20 September 2021	ITEM: 5
Lower Thames Crossing Task Force	
Lower Thames Crossing (LTC) – Consultation Response	
Wards and communities affected: All	Key Decision: Key
Report of: Colin Black, Interim Assistant Director, Regeneration and Place Delivery	
Accountable Assistant Director: Colin Black, Interim Assistant Director, Regeneration and Place Delivery	
Accountable Director: Sean Clark, Corporate Director of Resources and Place Delivery	
This report is Public

This report sets out the draft response of the Council to the non-statutory consultation from National Highways (previously known as Highways England, and heretofore referred to as HE) on the proposals for the Lower Thames Crossing (LTC) which commenced on 14 July 2021.

A Summary Review of Community Impacts Consultation has been prepared for Thurrock Council (the Council) to provide a review of the material presented as part of the Community Impacts Consultation exercise. Its purpose is to identify areas of concern, potentially significant issues and identify areas of further work required to be carried out by HE in order to allow the scheme to be properly and proportionately assessed, prior to DCO re-submission.

LTC Scheme Configuration, including A13 Junction

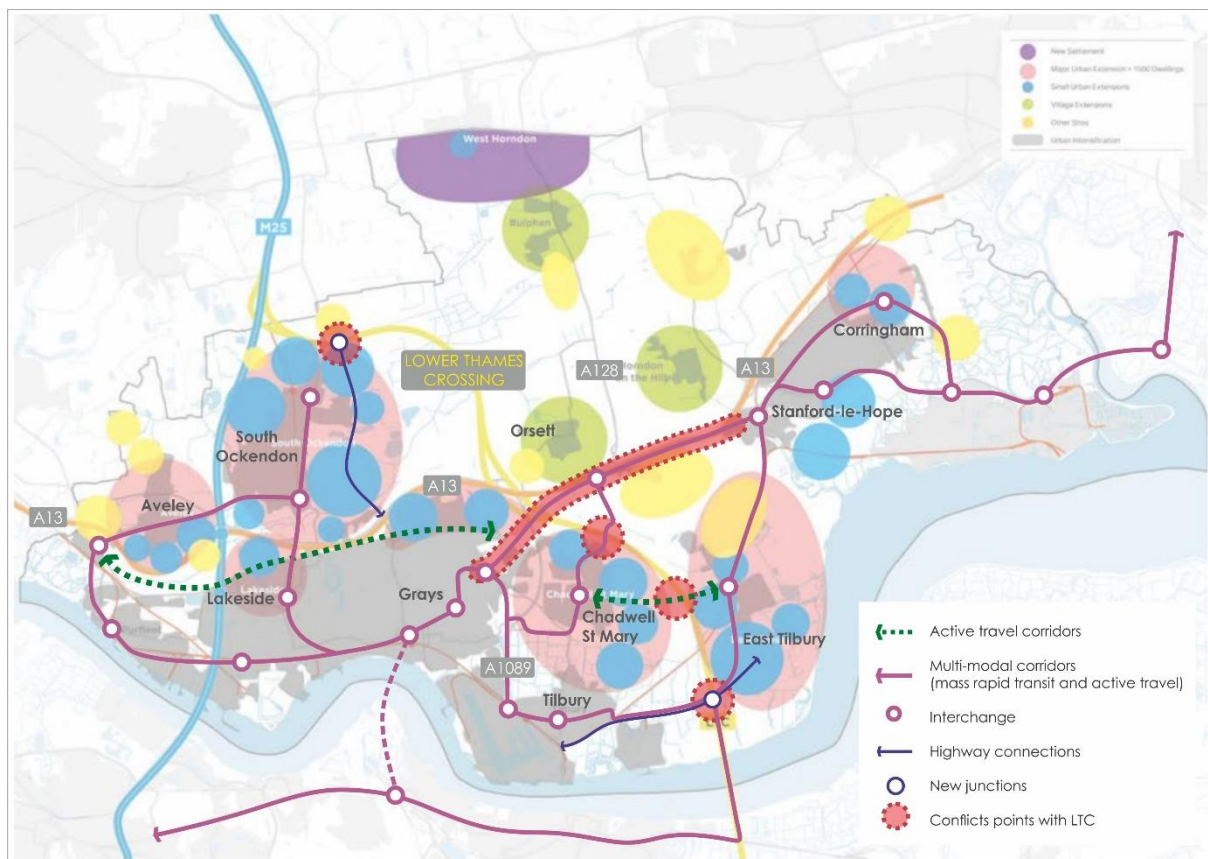
- 2.6.4 Evidence has been sought from HE as to the justification for the A13 junction and its configuration. In recent correspondence, HE has suggested that any options appraisal should be proportionate. The Council agrees with this position, however, it contends that significance of the impacts on the landscape of Thurrock, and the consequential impacts relating to property, severance, traffic delay and congestion, health, air quality, noise, accessibility and economy, (both in the temporary construction stage and permanent operational condition), means that there is a significant burden of proof resting with HE to justify the selected scheme design.

Figure 2-2: Route 1 from M2 J1 to the Port of Tilbury

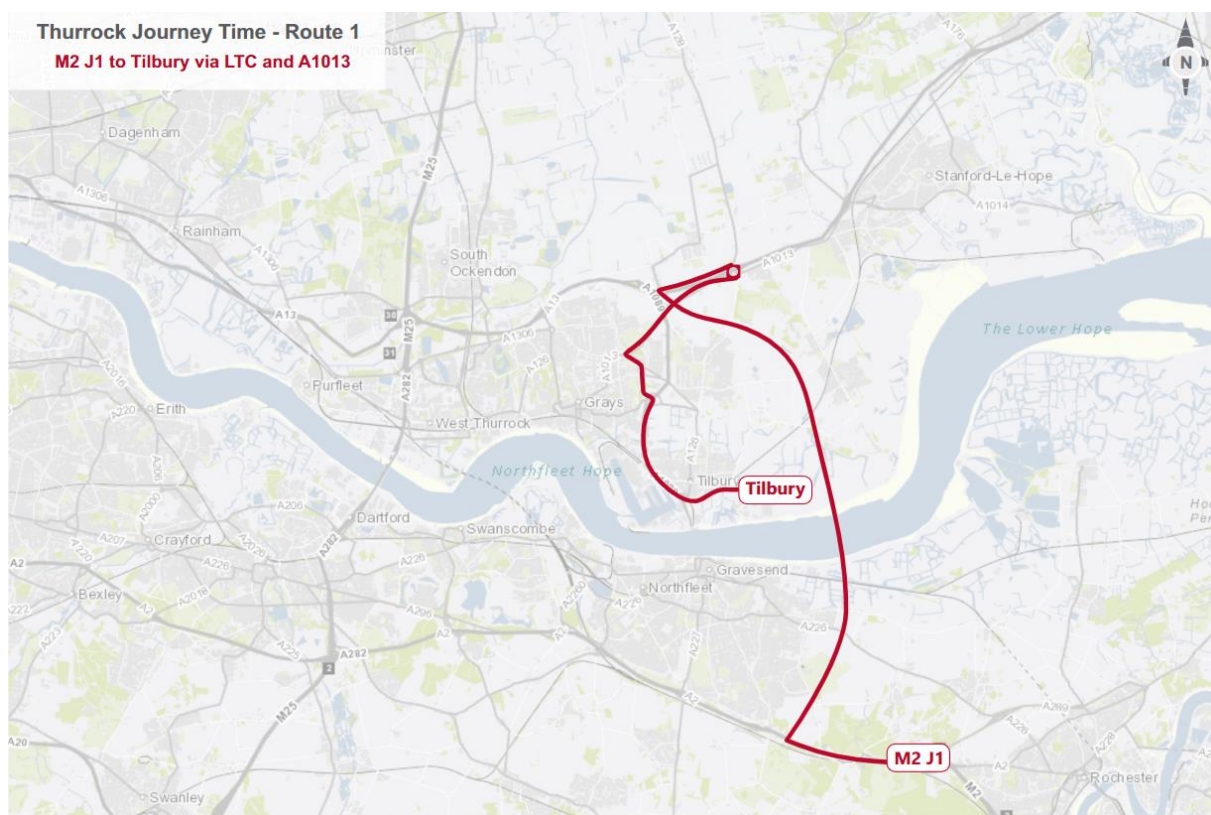
- 2.8.5 These reasons are not considered valid by the Council but seem to have guided HE's approach since that time, even though some reasons are now out of date.
- 2.8.6 It is clear that access to the Port of Tilbury, once the LTC scheme is completed and operational, will be circuitous from the LTC north and southbound. The routes vary but in order to access the Port from LTC, traffic would need to go either via the Orsett Cock Roundabout (along the A1013 to Daneholes Roundabout, via Wood View and Marshfoot Road to join the A1089), through Chadwell St. Mary (along Brentwood Road, via Marshfoot Road to join the A1089), U-turning at Manorway Roundabout (back along the A13 to the A1089) or use the existing Dartford Crossing. Routes from M2 Junction 1 to Tilbury are shown in Figures 2-2 to 2-4 below.

- 2.8.7 The local A roads and unclassified roads/junctions are not designed to accommodate these increases in traffic and/or HGV traffic. There are safety, air quality and noise concerns relating to increasing traffic and HGVs, particularly related to the schools, residential dwellings, and local bus services along these routes.
